Subject: Waterford 3 SES  
Docket No. 50-382  
License No. NPF-38  
Waterford 3 Cycle 10 Core Operating Limits Report

#### REVISION 2

Changes between Cycle 10, Revision 1, and Cycle 10, Revision 2, included in this revision are:

**COLR Figure 2A**

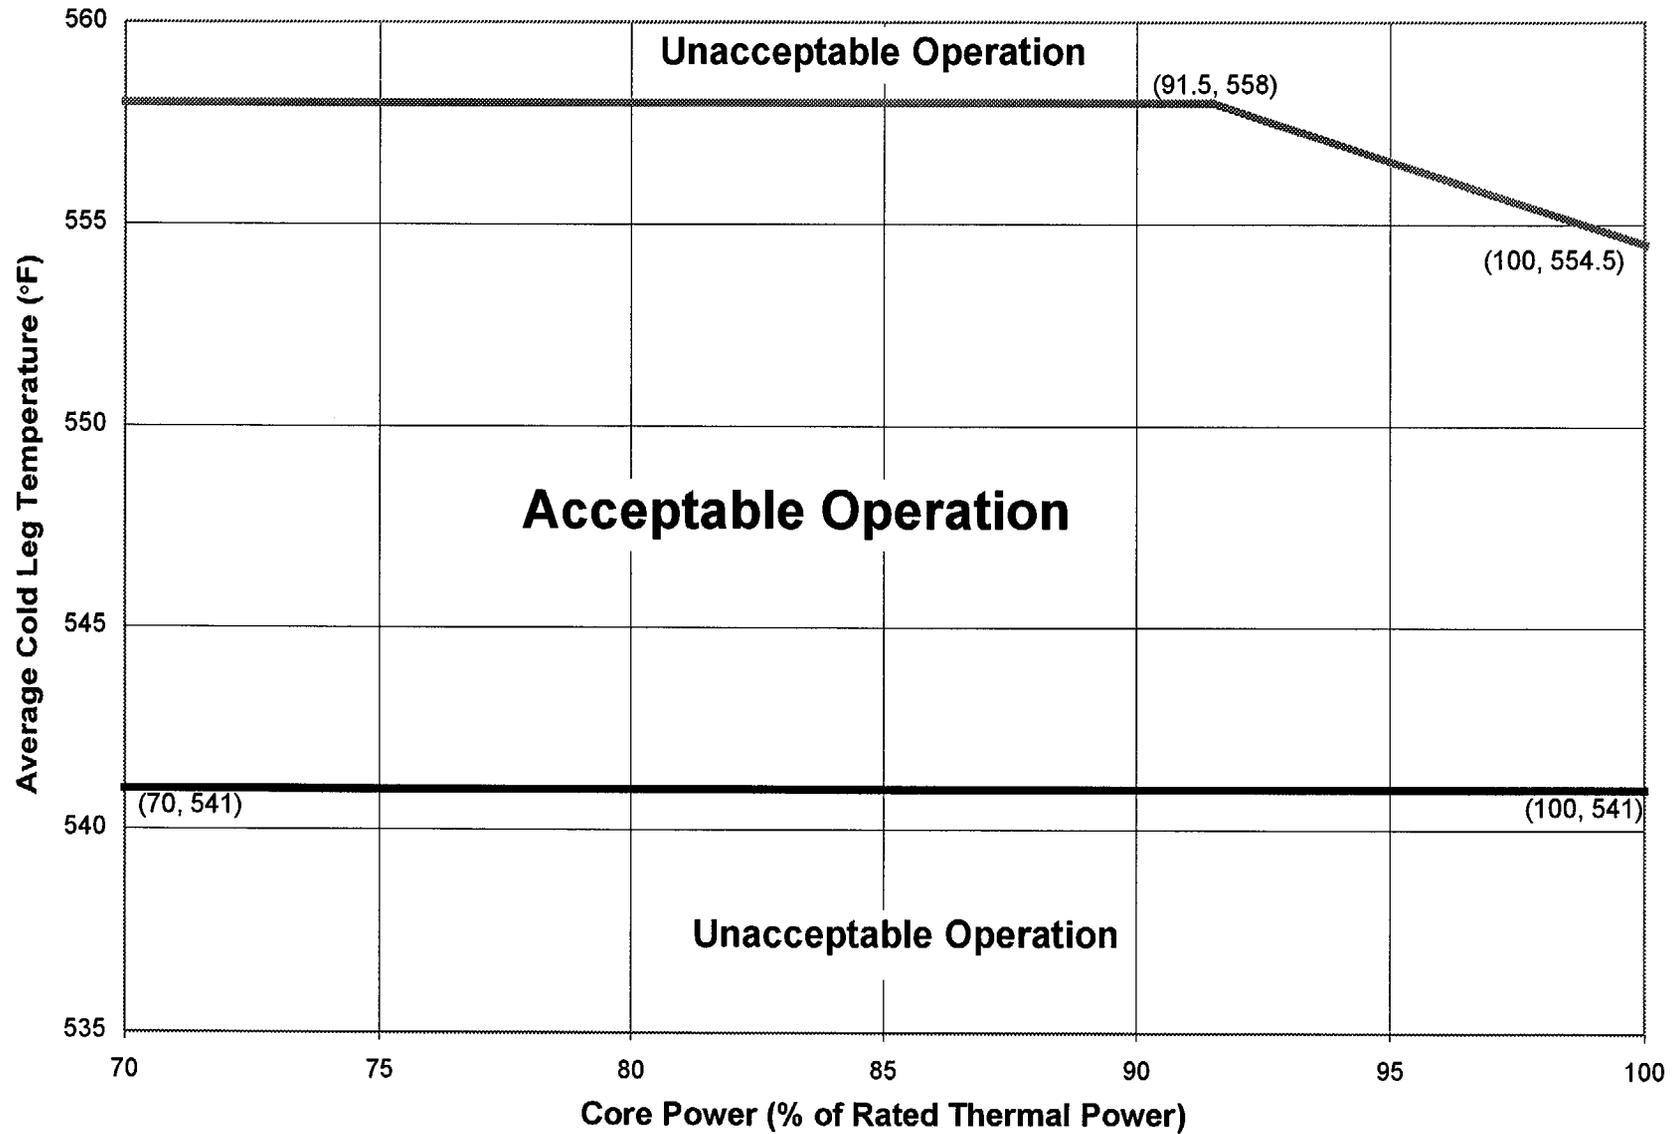
1. Modified Section 3.1.1.3 restriction to allow continued operation for the entire cycle.
2. Added Figure 2A, Figure 2B, and Figure 2C.
3. Modified Section 3.2.7 COLSS Out of Service power range to be consistent with the Technical Specifications.

- With the Critical Boron Concentration (CBC) less than or equal to 153 ppm and greater than 100 ppm, the COLR Figure 2A cold leg temperature and power restrictions shall be maintained within the region of acceptable operation.
- With the CBC less than or equal to 100 ppm and greater than 50 ppm, the COLR Figure 2B cold leg temperature and power restrictions shall be maintained within the region of acceptable operation.
- With the CBC less than or equal to 50 ppm, the COLR Figure 2C cold leg temperature and power restrictions shall be maintained within the region of acceptable operation.
